**COLCHESTER BOROUGH COUNCIL  
PLANNING COMMITTEE  
21 October 2010 at 6:00pm**

# **AMENDMENT SHEET**

**Planning Committee  
21 October 2010**

Not to scale

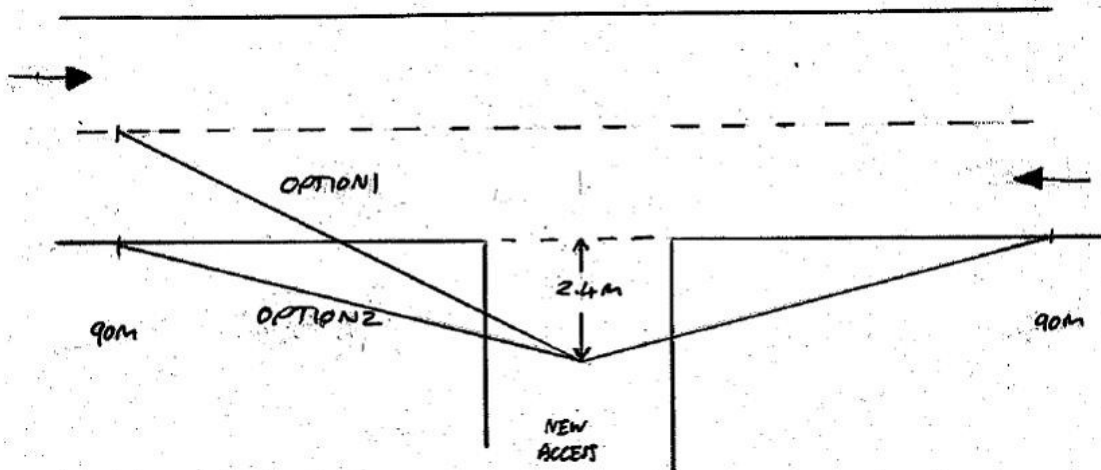
***"Please be advised that following discussion and investigation on the above application, this Authority has received the two versions of the access plan showing the 2 options for visibility splays.***

***Whilst option 2 is preferred, were the Local Planning Authority to grant permission for option 1 no objections would be raised.***

**The highway response refers to two options showing the vehicular access. Both options show visibility splays measuring 2.4 metres by 90 metres to the south and 2.4 metres by 90 metres to the north. However, 'Option 1' shows to the 2.4 metres by 90 metres splay measured from and along the highway boundary to the north, while to the south it is measured from the highway boundary to the centre line of the road. 'Option 2' shows the 2.4 metres by 90 metres splay measured to the edge of the highway in both directions, as would normally be required.**

The Highway Authority would prefer 'option 2', however, this option would require the removal of a greater length of hedgerow in order to facilitate sight splays which would conflict with the Hedgerow Regulations 1997. As mentioned in para 11.4 of the report 'option 1' was developed to avoid the need to remove a larger section of hedgerow in order to facilitate sight splays and can be achieved by facing back a section of the existing hedge.

- 1) Provision of visibility splays measuring 2.4m x 90m in both directions,***
- 2) Pedestrian visibility splays measuring 1.5m x 1.5m on both sides of the access***

The Highway Authority have confirmed that they would not object to permission being granted for 'option 1' as is recommended here. This would still allow for visibility of oncoming vehicles in both directions.

- 12. Prior to the first use of the new access, the access at its centre line shall be provided with a clear to ground visibility splay with dimensions of 2.4 metres by 90 metres to the south and 2.4 metres by 90 metres to the north, as shown on drawing no 08/6024/04B (option 1). Such vehicular visibility splays shall be provided before the access is first used by vehicular traffic and retained free of any obstruction at all times.  
Reason: To provide adequate inter-visibility between vehicles using the access and those in the existing public highway in the interest of highway safety.**
